**STAFF REPORT AND RECOMMENDATION
TO THE HEARING EXAMINER**

Report Date: November 17, 2023
Report Submitted By: *KW* Karen A. Witherspoon, AICP
Senior Project Planner
File Number: LP22-00002 (Hearing Number 23-1-001 – Docket Item 1)
Project Name: Sunfisher Subdivision
Type of Action: Type III – Subdivision application (Formal Long Plat)

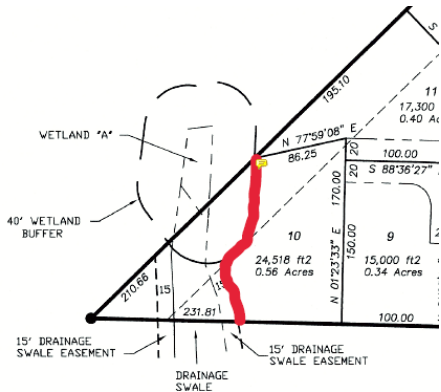
There is a seasonal drainage located on the western portion of the project area. Seasonal drainages are not classified as stream requiring a critical areas stream buffer. However, Lewis County Code (LCC) Section 16.05.330(3) does require seasonal drainage to establish an easement extending 15 feet landward from the ordinary high water mark. The seasonal drainage and the 15-foot easement located on the landward side of the ordinary high water mark is shown on the Revised Preliminary Plat Drawing submitted on October 11, 2023 (Exhibit 9 – Revised Preliminary Plat Drawing).

The County GIS layer does not indicate there are mapped wetlands and mapped hydric soils within the boundaries of the proposed subdivision, but during the SEPA and Notice of Application comment period, comments from Ecology staff indicate the nearby off site wetland appeared to be connected to the seasonal drainage and should be investigated to determine if wetland exist onsite. As the GIS layer is the initial tools used to determine if wetland might be present. The applicant submitted an initial critical area report from Environmental Design dated December 5, 2022 (Exhibit 9 – Critical Area Report). Ecology Staff and County staff reviewed the report and determined a site visit was needed to adequately review the findings.

A site visit with the applicant's consultant and Ecology staff on August 1, 2023 determined there is a wetland located off site to the west of the proposed subdivision, and the 40-foot wetland buffer is located in the western portion of the proposed subdivision within the area of the seasonal drainage and other development setbacks on Lot 10 (see drawing below). The Final Critical Area Report from Environmental Design, LLC dated August 22, 2023; Revised on September 19, 2023, was accepted as final by Ecology and Lewis County on October 3, 2023 (Exhibit 9 – Critical Area Report 2023-09-19). ***The following conditions of approval should be included in the preliminary decision document:***

- ***The final plat drawing shall include the location of the seasonal drainage, the 15-foot easement for the seasonal drainage, the location of the wetland and the location of the 40-foot wetland buffer.***

- *The vegetation located within proposed Lot 10 lying west of the eastern edge of the 40-foot wetland buffer and the easternmost edge of the 15-foot drainage swale easement shall be retained on site and noted as retained on the final plat drawing.*
- *The following statements shall be listed on the Final Plat drawing as “Conditions of Development”:*
 - *The vegetation located within proposed Lot 10 lying west of the eastern edge of the 40-foot wetland buffer and the easternmost edge of the 15-foot drainage swale easement shall be retained on site.*
